Marked-up St. Lucie Unit 1 Technical Specification Pages:

Marked-up St. Lucie Unit 2 Technical Specification Pages

## ATTACHMENT 3

These proposed license amendments are intended to make corrections to typographical errors in the Administrative Controls, delete the Company Nuclear Review Board (CNRB) specific composition list and replace it with a general statement defining the requisite level of expertise for membership, and revise the Independent Safety Engineering Group (ISEG) reporting and administrative requirements (St. Lucie Unit 2 only).

TOPICAL QUALITY ASSURANCE REPORT	
ORGANIZATION OF DEPARTMENTS AFFECTING QUALITY CASE 84122021.NCI FIGURE 1-1 APPENDIX A	REV. 1.4 DATE 11-0-77-M PAGE 1 OF 1

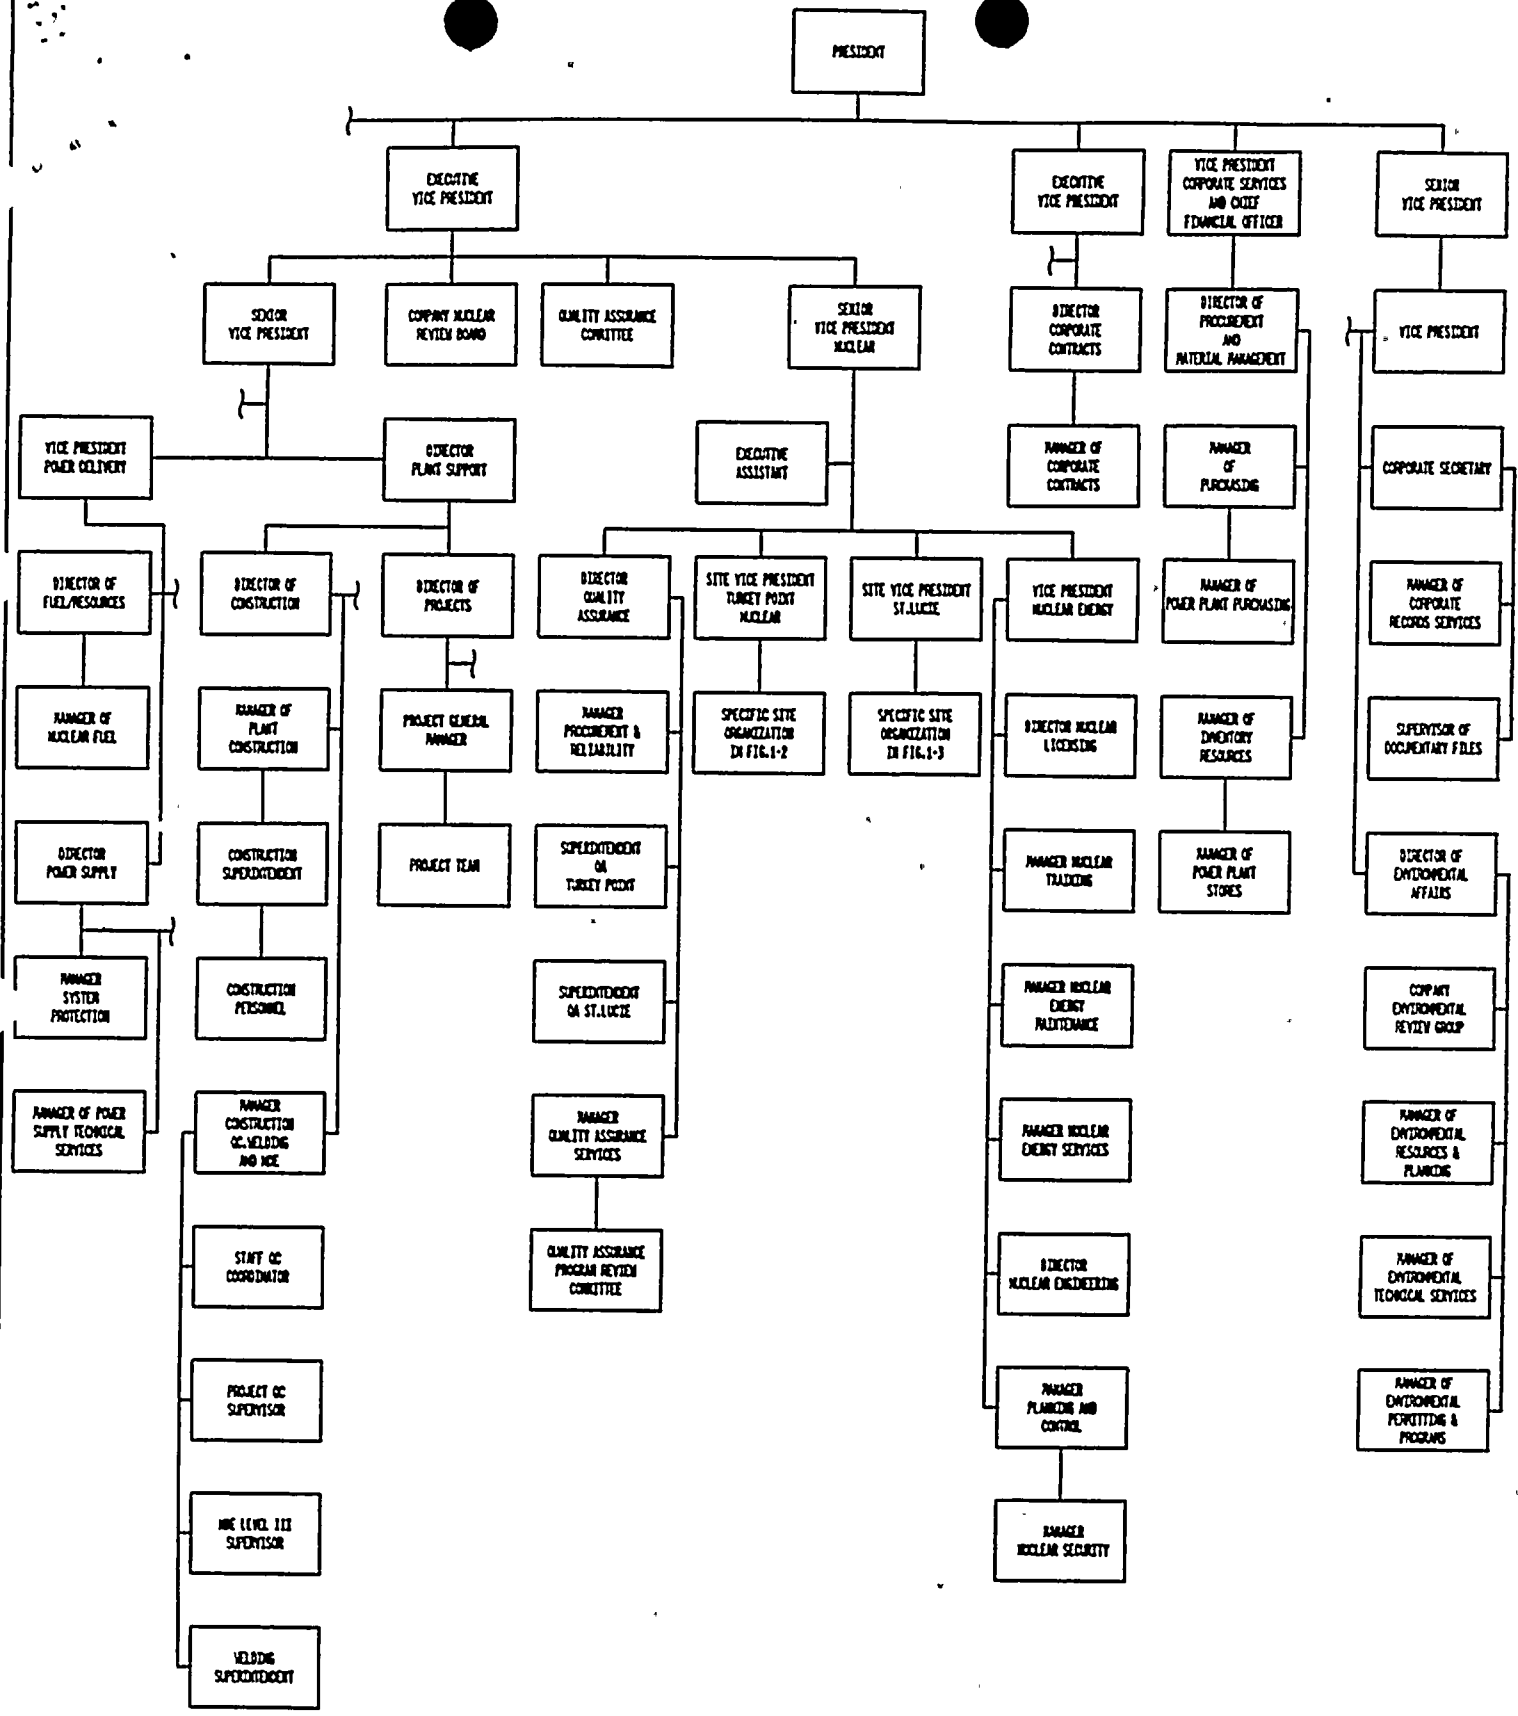
Since the Plant Manager is "... responsible for overall unit safe operation..." and has "... control over those onsite resources necessary for safe operation and maintenance..." his responsibility, as indicated in Figure 1-1 confirms him as FPL's line manager for St. Lucie Unit 2. While assigned to the site, and physically located there, the Site Vice President - St. Lucie can be seen to be in an oversight mode for safe operation and maintenance of the unit. This position makes him uniquely qualified to receive the reports of the ISEG. His day-to-day presence at the site puts him in the best position to appreciate all aspects of the independent examination of plant operating characteristics, NRC issuances, and other appropriate sources of plant design and operating experience information that may indicate opportunities for further enhancing plant safety.

As a result, it is proposed that Specification 6.2.3.2 be revised to require non-degreed candidates for the ISEG be approved by the Site Vice President - St. Lucie prior to joining the group; that Specification 6.2.3.3 be revised to require the ISEG to make its detailed recommendations to the Site Vice President - St. Lucie; that Specification 6.2.3.4 be revised to delete "offsite" and to require the ISEG to report to the Site Vice President - St. Lucie; and that Specification 6.2.3.5 be revised to require ISEG activity reports be forwarded to the Site Vice President - St. Lucie each calendar month.
